# VALUE ENGINEERING STUDY

Project # CSSTP-0007-00(319) PI No. 0007319

SR 347/Lanier Islands Parkway from  
Lake Lanier to McEver Rd  
Hall County, Georgia

09 May 2013

# PROPOSED CHANGE SKETCH/DETAIL

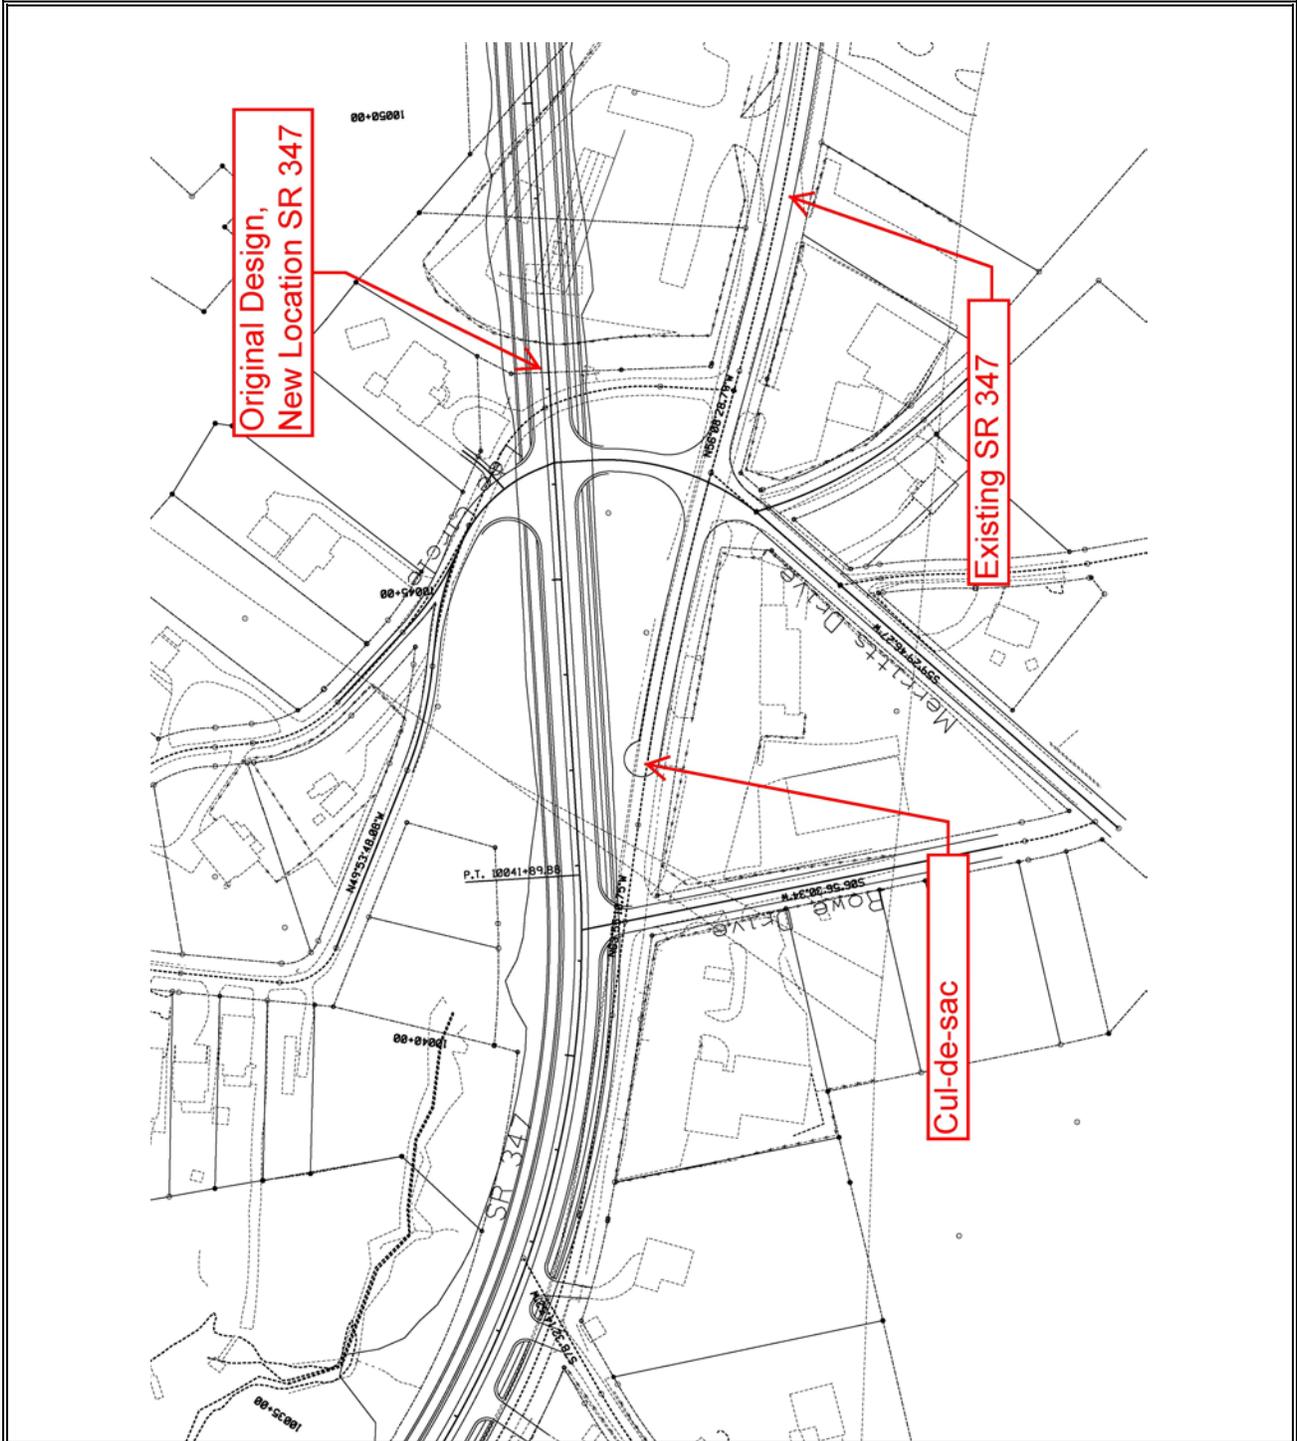
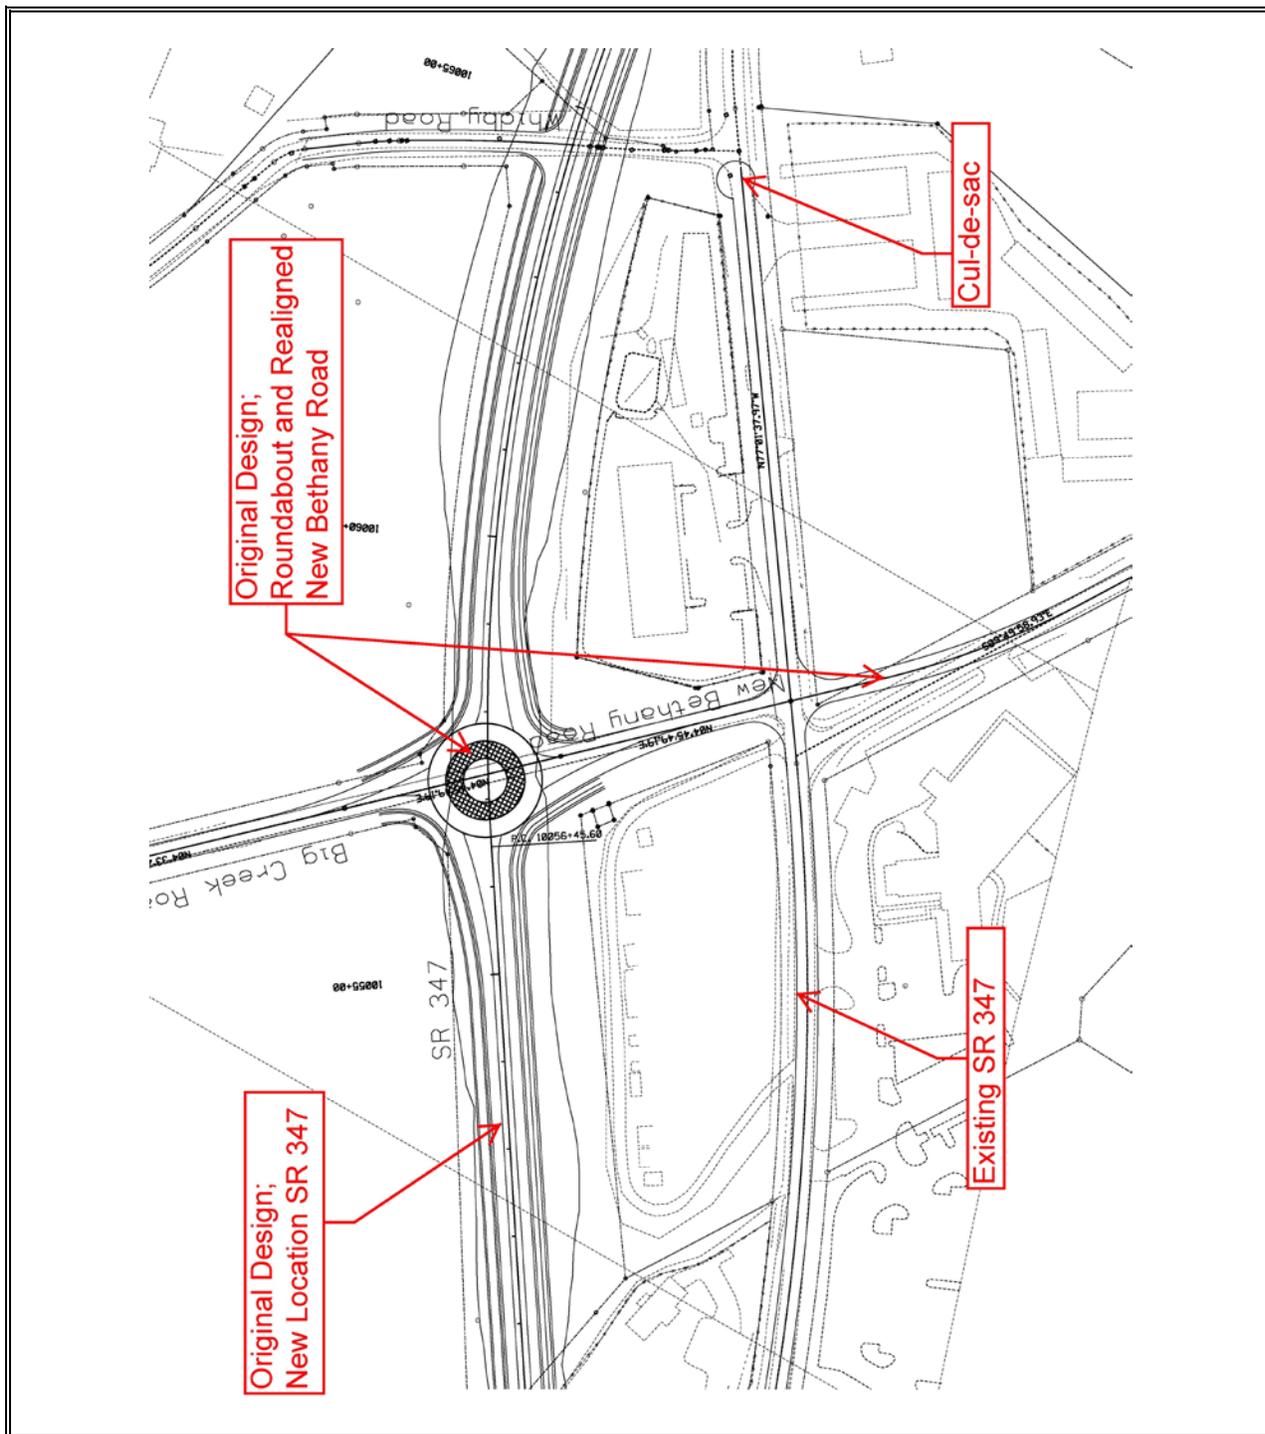
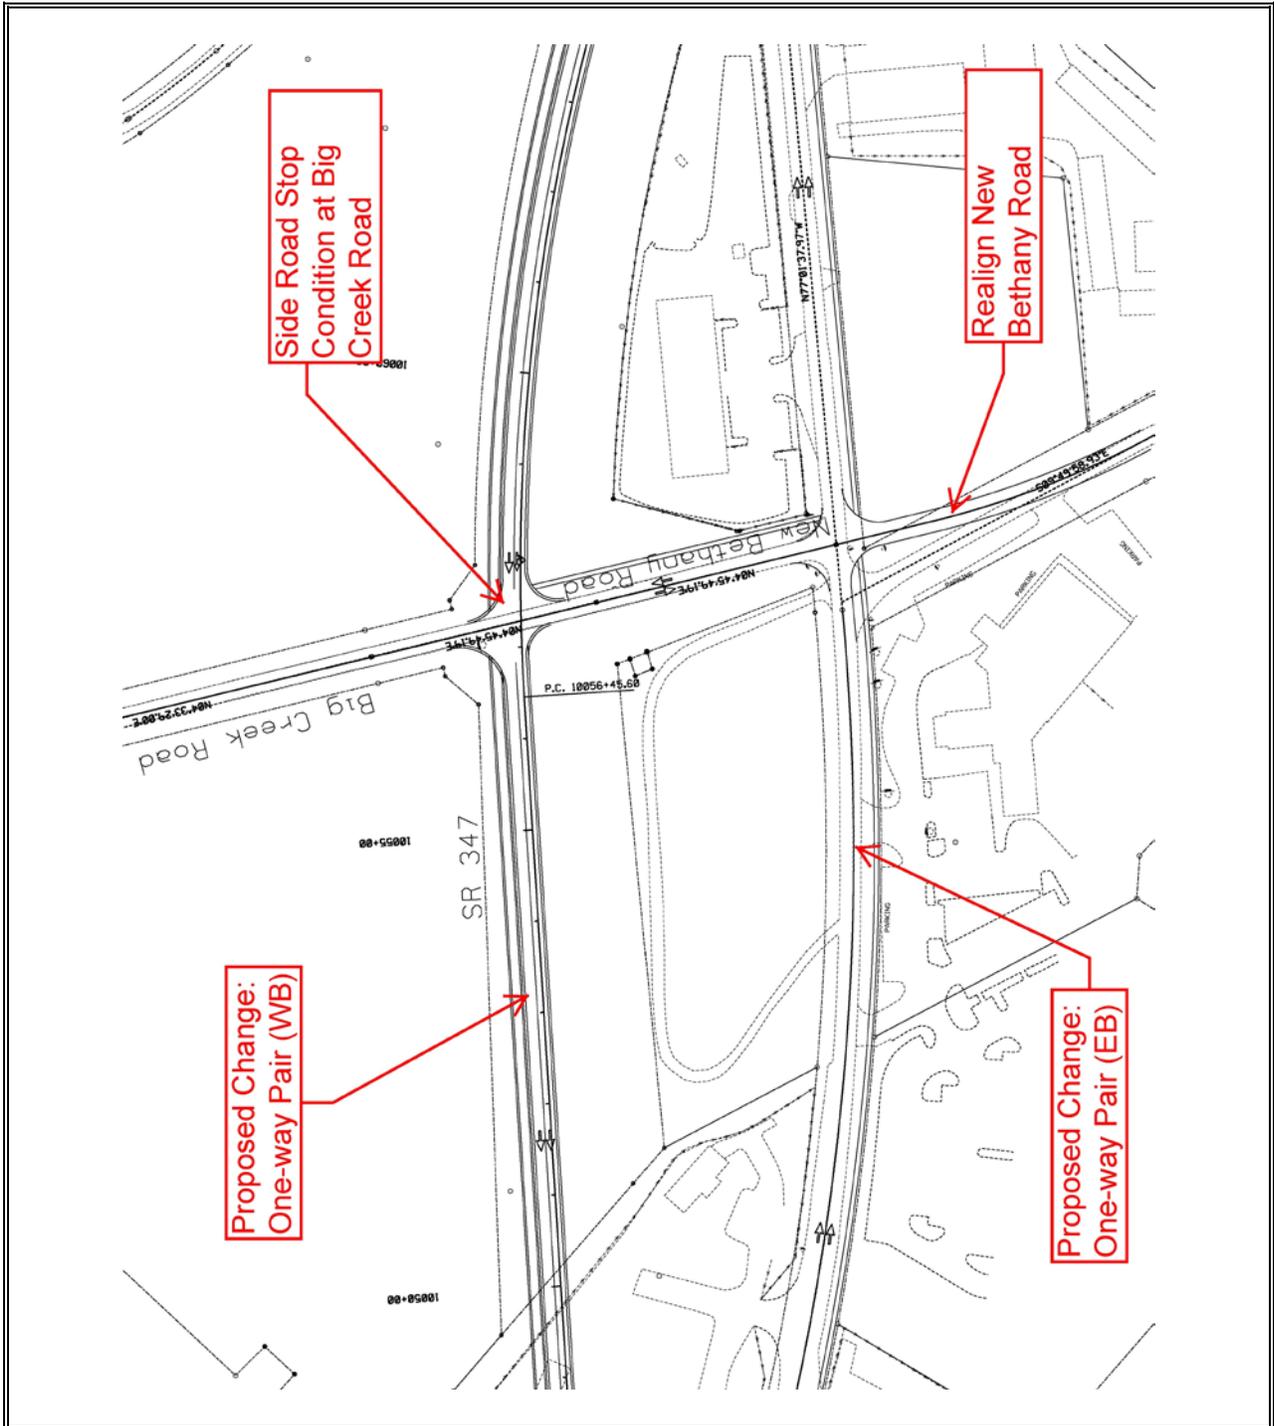
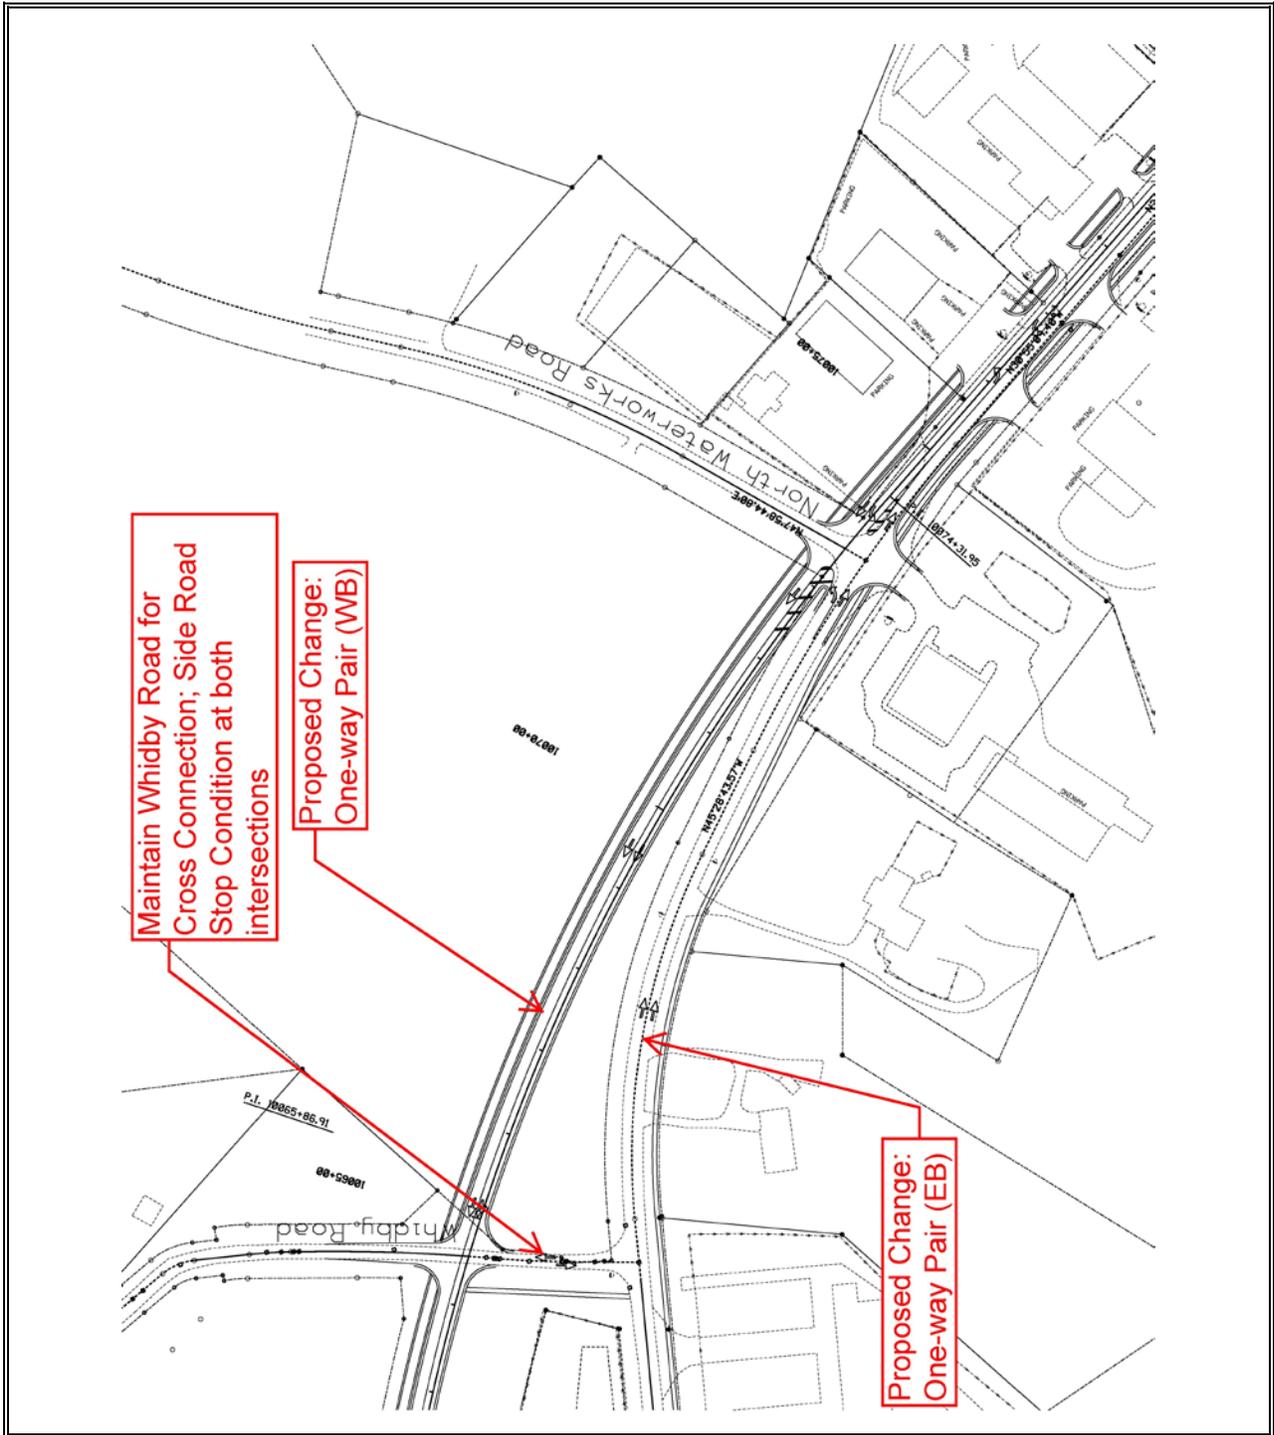
**PROPOSED CHANGE:** The existing two-lanes of SR 347 would be converted into a one-way eastbound rural roadway from Rowe Drive to North Waterworks Road (no change proposed to roadway typical section). A new two-lane one-way westbound roadway would be constructed along the new location alignment within these same limits. Two-way, two-lane cross connections would be provided at Lee Circle/Merritts Drive (realigned roadway), Big Creek Road/New Bethany Road (existing roadway), and Whidby Road (existing roadway). All intersections would be side road stop condition. A 10-foot multi-use trail would be provided along the north side of the new alignment roadway section (one-way westbound lanes); a 5-foot sidewalk offset from the edge of pavement would be provided along the south side of the existing rural SR 347 roadway (one-way eastbound lanes); and 5-foot sidewalk cross connections would be provided along each roadway cross connection: Lee Circle/Merritts Drive, Big Creek Road/New Bethany Road, and Whidby Road.

**JUSTIFICATION:** The primary reason for not widening the existing SR 347 to a three-lane section was to avoid impacts to an existing cemetery and church located at the intersection with Big Creek Road/New Bethany Road. This proposal allows the capacity and operations improvements to occur within the area without impacting the resources in a negative manner and minimizes business impact concerns expressed by local business owners in the May 5, 2013 article published in the Gainesville Times (“Plans for Ga. 347 Include Roundabout”, Jeff Gill, Management Edition). In addition, this proposal provides flexibility to allow two-lane outbound traffic following major events at Lake Lanier Islands.

Figure 9.7. Illustrations of Pedestrian Facility Design – Urban Border Area.

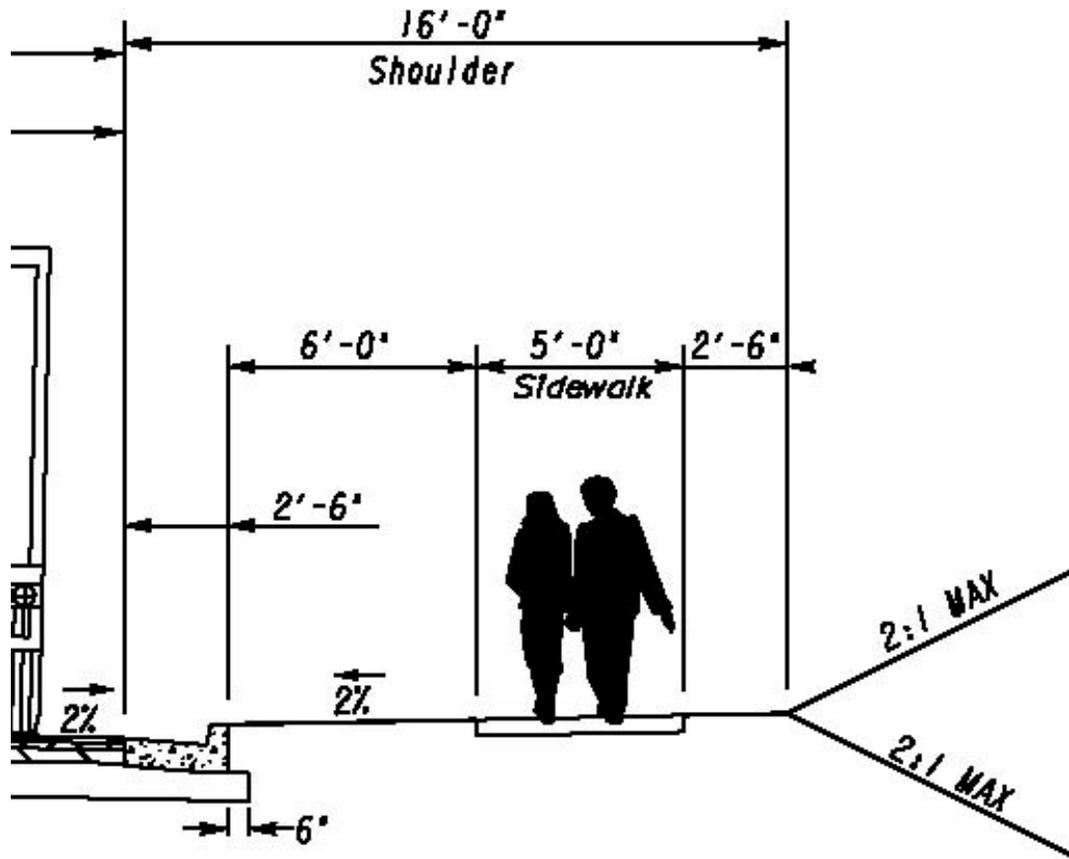
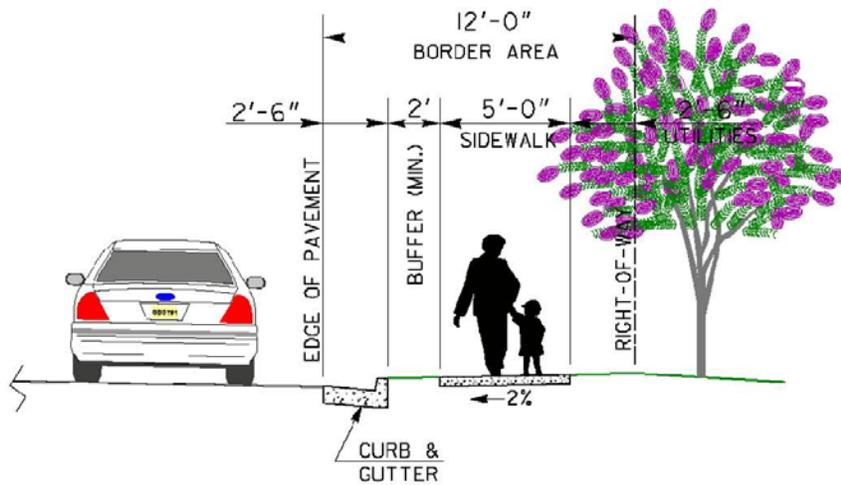
**PROPOSED CHANGE:** The proposed change is to reduce the width of the shoulder on the sidewalk side from 16'0" to 12'0". The grass strip between the back of the curb and the sidewalk will be reduced to 2'0".

**JUSTIFICATION:** The GDOT Design Policy Manual Section 9.5 Figure 9.7 shows the location of the sidewalk on an urban roadway on either a 16'0" or a 12'0" shoulder. Thus, this change meets GDOT Design Policy while reducing property impacts and providing a construction cost savings.

Proposed Change: Revise from 16' to 12' shoulder width on sidewalk side of roadway to match sketch below from GDOT Design Policy Manual

# ORIGINAL DESIGN SKETCH/DETAIL

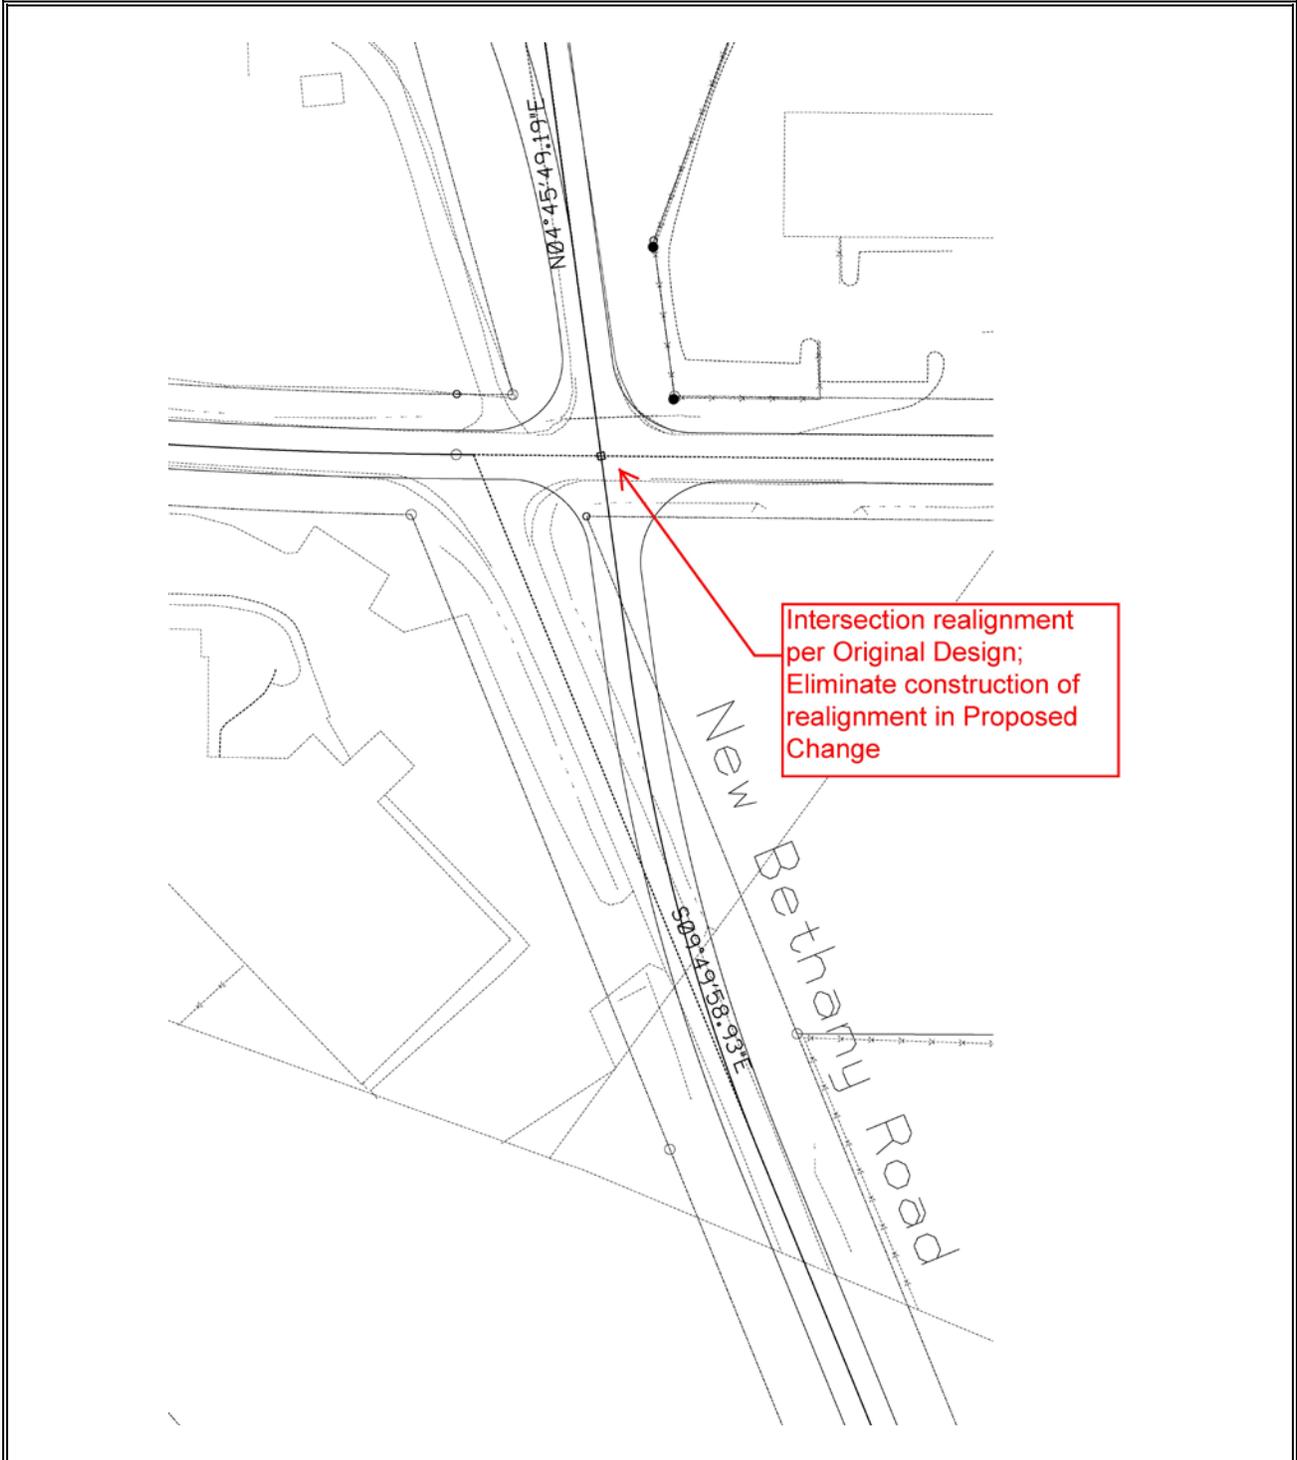
**PROPOSED CHANGE:** It is proposed to eliminate all construction at this intersection and leave the alignments separated by 60 feet as currently exists.
